From: Yola Bayram [ybayram@awrcorp.net]
Sent: Thursday, December 03, 2015 6:47 PM
To: Detterman, Mark, Env. Health
Cc: Steve Michelson
Subject: Addendum for 1700 Jefferson Work Plan RO#151
Attachments: 2015 08 27 Sample Table.pdf; F1a_Proposed_Sampling_Location_8-27-15.pdf; F1_Proposed_Sampling_Locations_9_22_2015.pdf

On behalf of ARC and based on phone conversations, email correspondence, and our on-site meeting with Lance Lo, the apartment building property owner, on July 31, 2015, this email provides the following as an addendum to the *2013 Conceptual Site Model and Work Plan for 1700 Jefferson Street, Oakland, California and Foundation Depth Survey Report*.

Figure - 1
Proposed Sampling Locations
1700 Jefferson Street, Oakland, CA

Figure - 1a
Proposed Sampling Locations
Detail Map
 1700 Jefferson Street, Oakland, CA

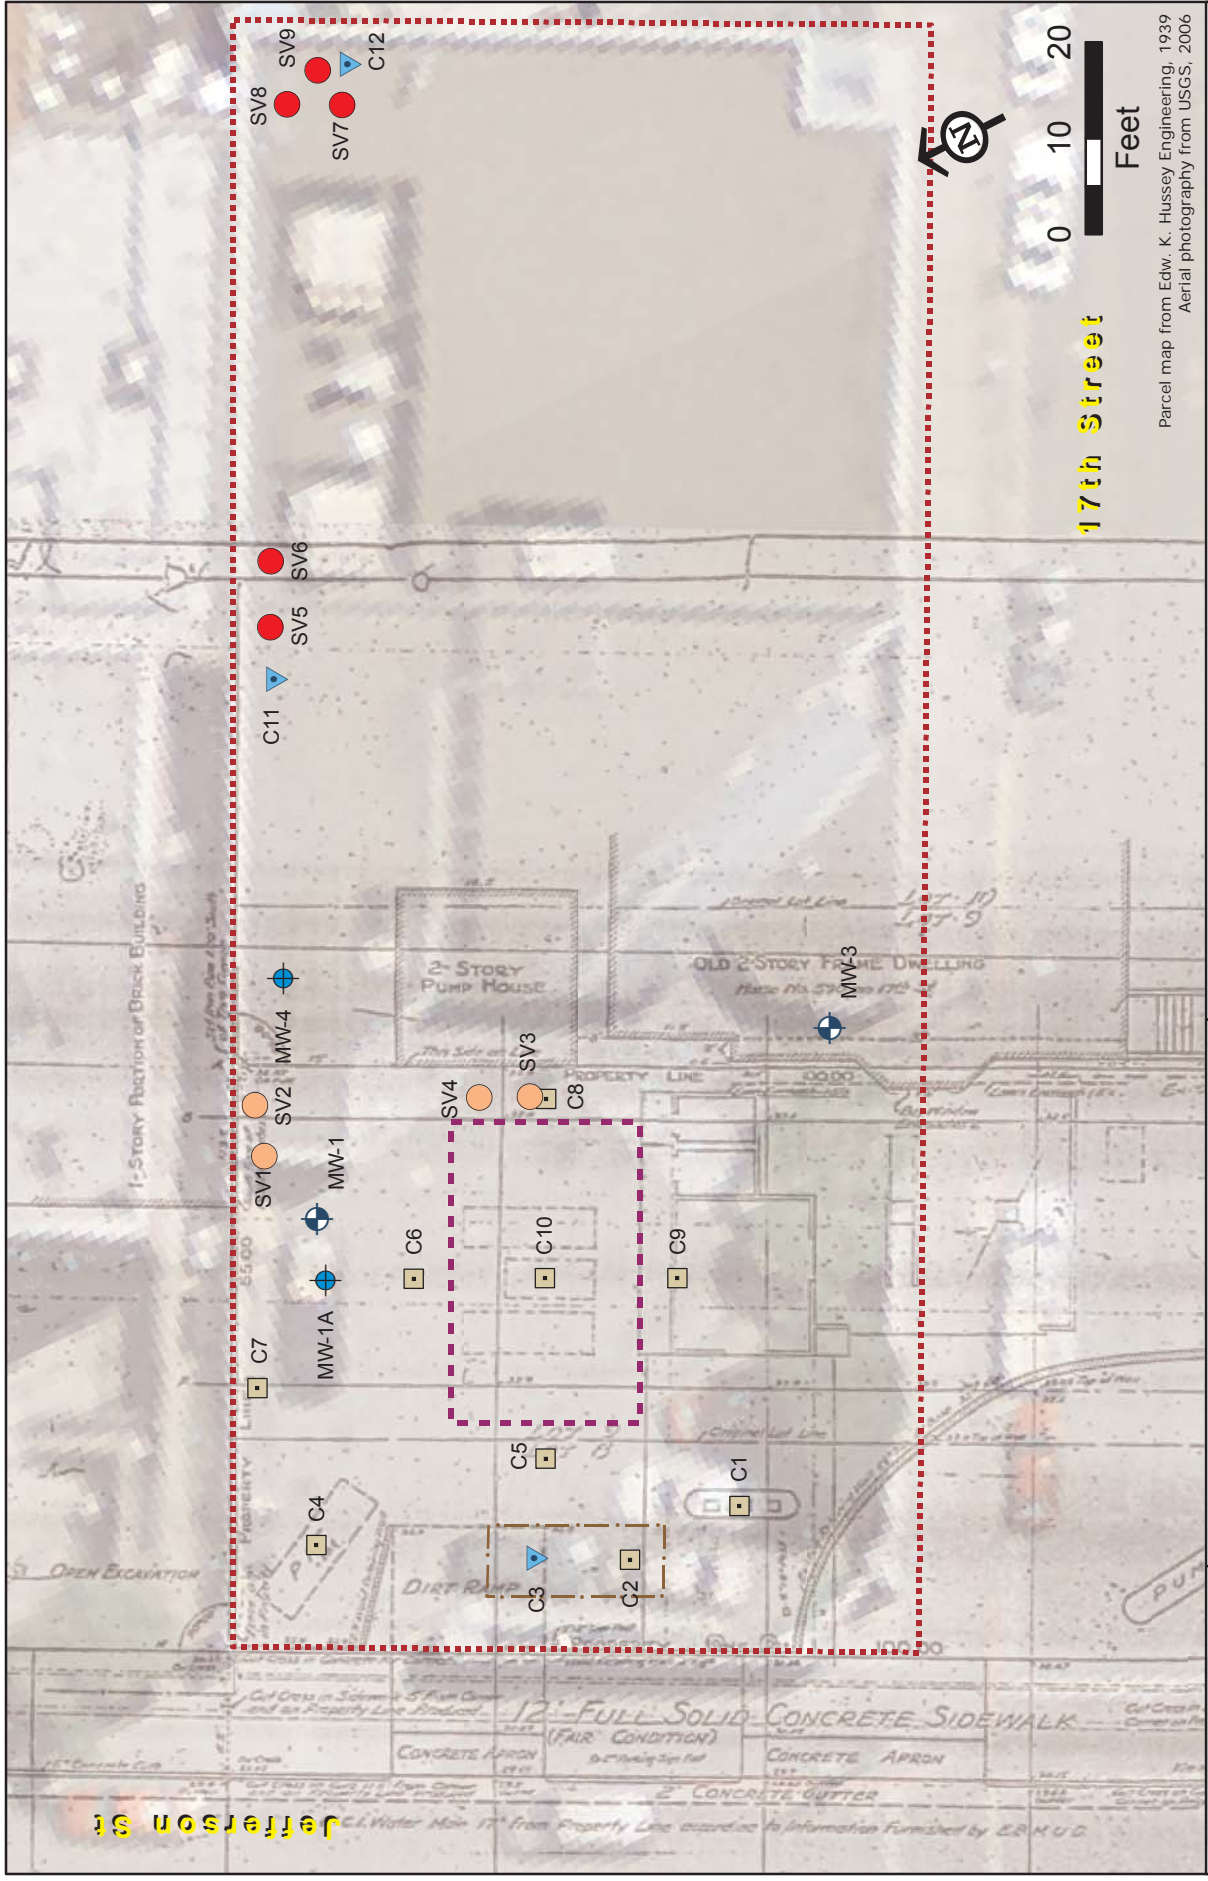
- Table 1 provides the rationale, sample depths, and analyses for each soil boring.
- Table 2 provides the rationale, sample depths, and analyses for each soil vapor location.
- Figures 1 and 1a show the additional borings proposed to be advance.

- Install 7 soil vapor wells at various depths adjacent to the neighboring apartment's courtyard and on the property,
- Advance 10 temporary soil vapor points within the on-site building, on Jefferson St, and on 18th Street to assess risks to occupants in the apartment building, on-site building, and neighboring properties,
- Advance one additional boring on-site adjacent to the courtyard to collect soil samples,
- Advance one additional boring on Jefferson Street to sample ground water; and
- Advancing one boring near MW-5, in the area of patch in the sidewalk to collect soil samples and two soil vapor samples from different depths.
